Amendment A00001

Questions received from potential quoter's, as well as answers.

RENOVATE S.I.C.U.
VA WESTERN NEW YORK
HEALTHCARE SYSTEM

CONTRACT NO. 95B-350 - RENOVATE S.I.C.U.
PROJECT NO. 528-301
BUFFALO, NEW YORK 14215

DOUBLE LINE H.V.A.C. LAYOUT
PLAN - AREA "D"
SCALE: 1/8" = 1'-0"

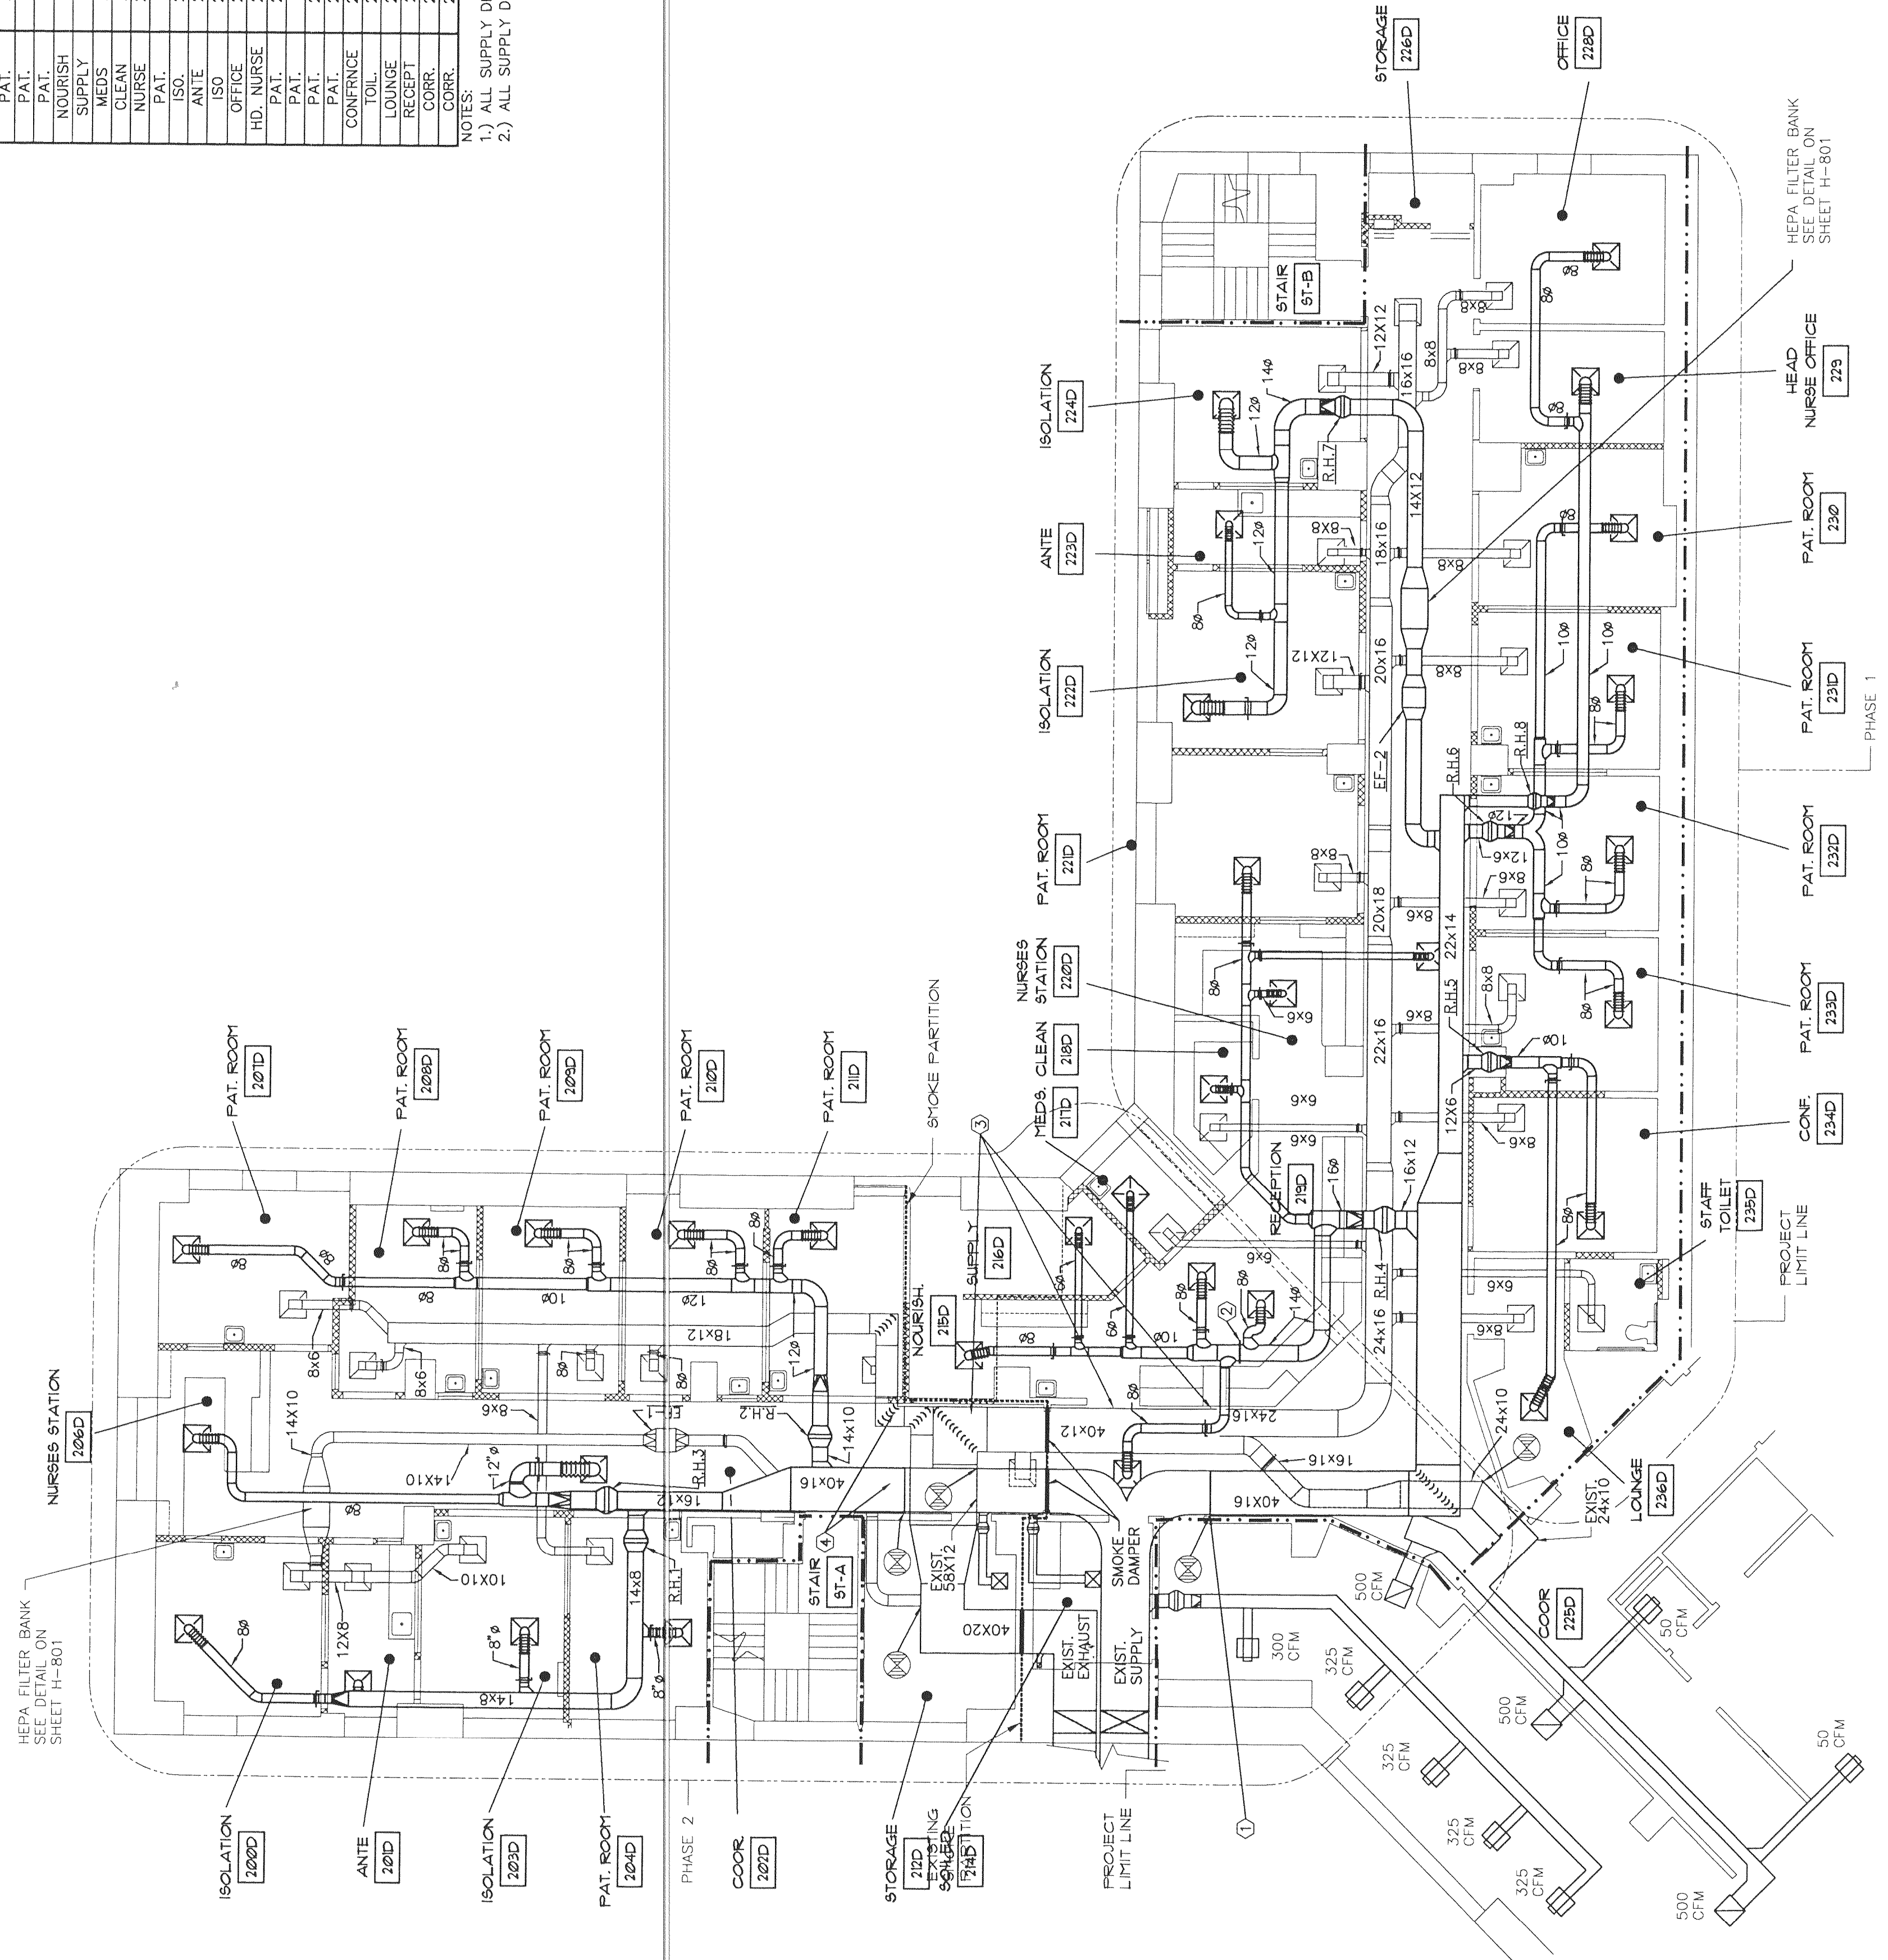
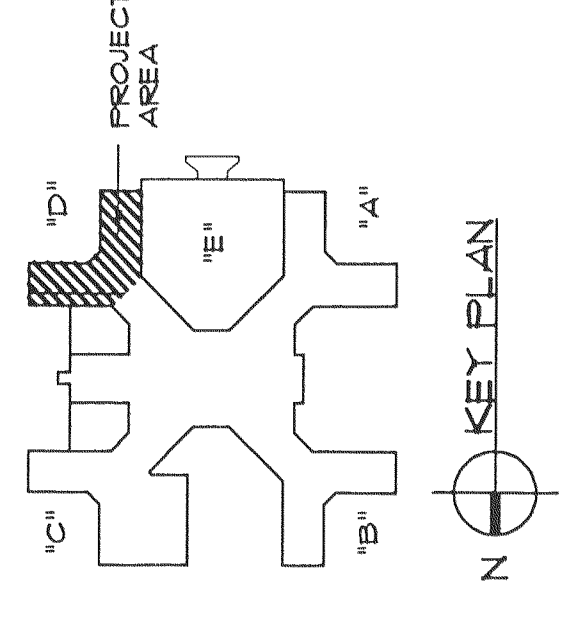
Can you provide HVAC plans for the Surgical Intensive Care Unit (SICU) and Post-Anesthesia Care Unit (PACU)?

What is the approximate ductwork length for these systems?

See below schematic.

See below schematic.
